BUILDING INSPECTION
PERMIT

Permit Number: 061423

This is to certify that KING CONSTRUCTION COMPANY / King Construction Corphas permission to New Single Family Home- with Car garageAT STEPPING STONE LN #9

LOT 9 - GRADING PLAN
 AUTUMN GLEN SUBDIVISION

LOT 9 - GRADING PLAN
AUTUMN GLEN SUBDIVISION

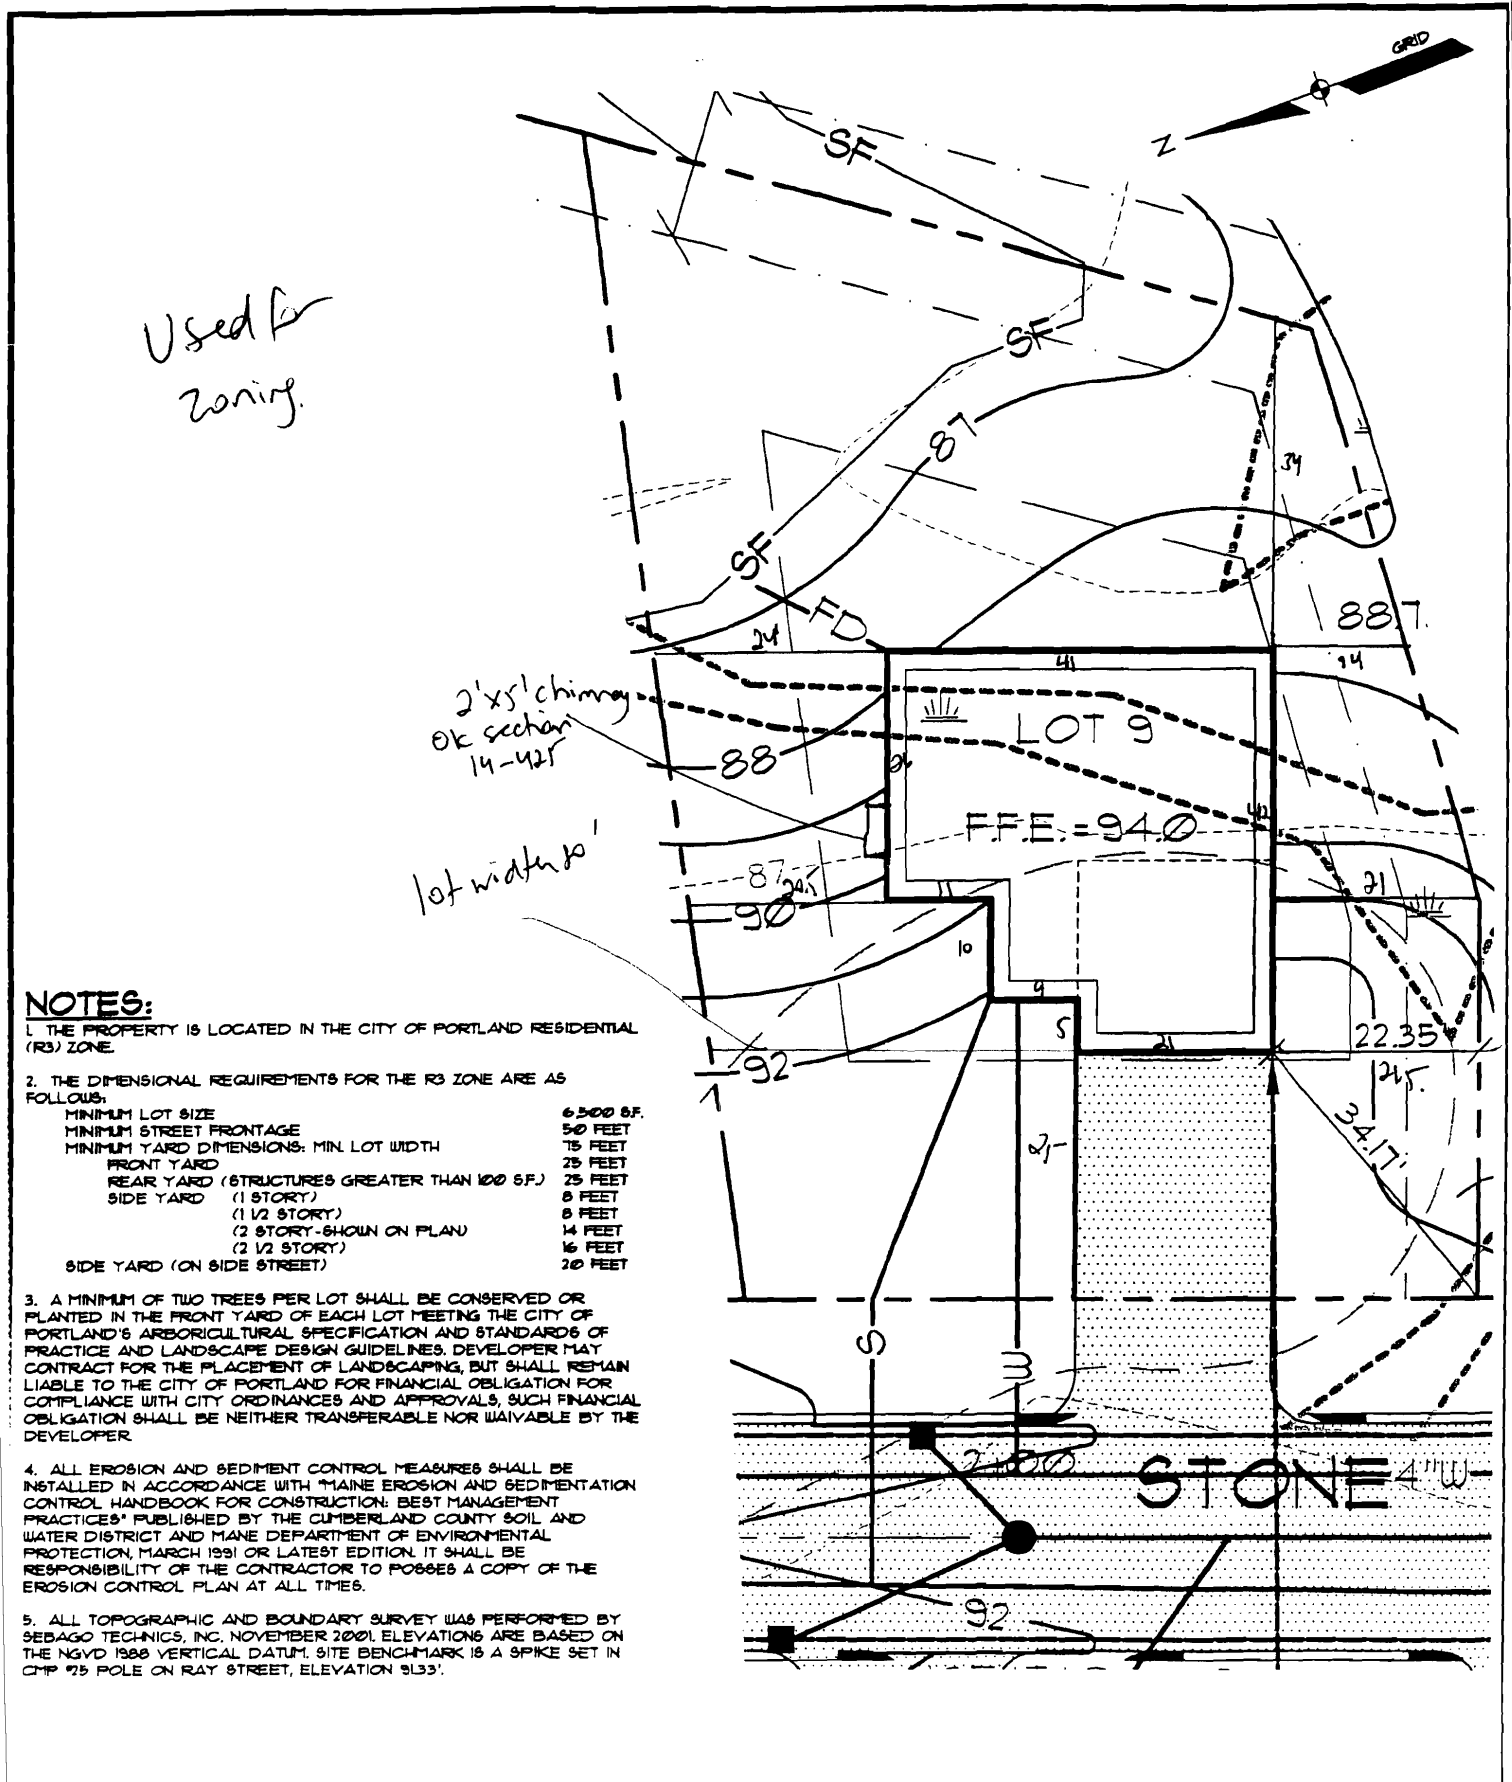
10/4/2006-amachado: Elevation plan shows daylight basement in rear. Grading plans does not match. Left message for King Weinstein to call me.

- no * daylight basement.

CRAWL FOUNDATION PLAN
1/4" = 1'-0"

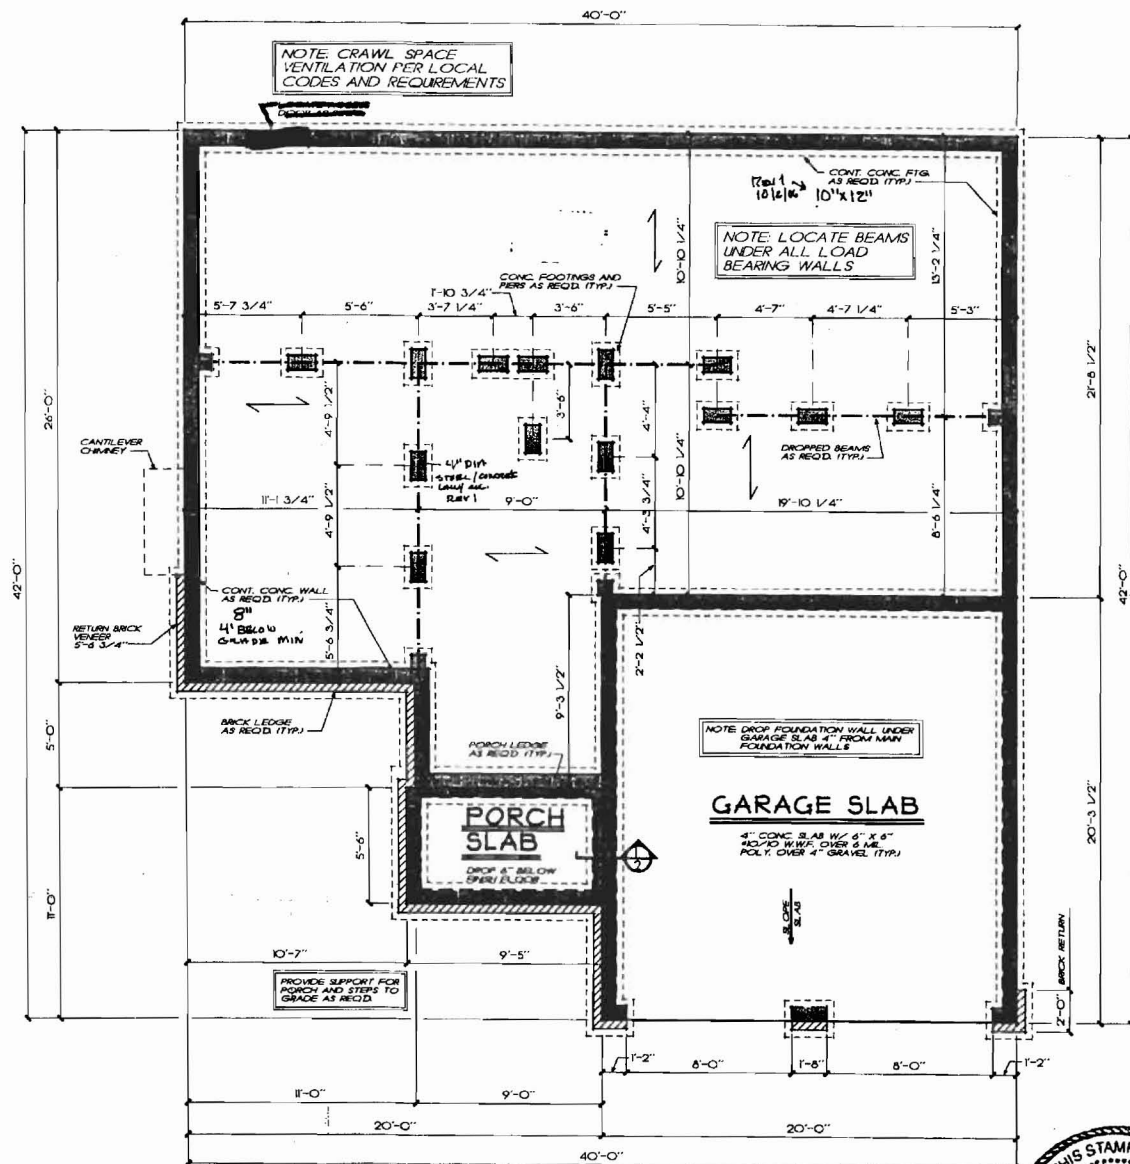
ONE AND TWO FAMILY	PLAN REVIEW	CHECKLIST
Soil type/Presumptive Load Value (Table R401.4.1)		
STRUCTURAL		
④ Footing Dimensions/Depth (Table R403.1 & R403.1(1), (Section R403.1 & R403.1.4.1)	Noted - not large enough	Pg 2 + SA - OK
Foundation Drainage, Fabric, Damp proofing (Section R405 & R406)	Hand noted on sheet #2	
Ventilation/Access (Section R408.1 & R408.3) Crawls Space ONLY	N/A	
⑤ Anchor Bolts/Straps, spacing (Section R403.1.6)	not shown	Pg 2 - OK
Lally Column Type (Section R407)		
Girder & Header Spans (Table R 502.5(2))	3-2x10's - 5'-4" Max span	- OK
Built-Up Wood Center Girder Dimension/Type	" "	
③ Sil/Band Joist Type & Dimensions	not shown	Pg SA - OK
First Floor Joist Species Dimensions and Spacing (Table R502.3.1(1) & Table R502.3.1(2))	2x10's - OK	
Second Floor Joist Species Dimensions and Spacing (Table R502.3.1(1) & Table R502.3.1(2))	2x10's - OK	
Attic or additional Floor Joist Species Dimensions and Spacing (Table R802.4(1) and R802.4(2))	2x8's - OK
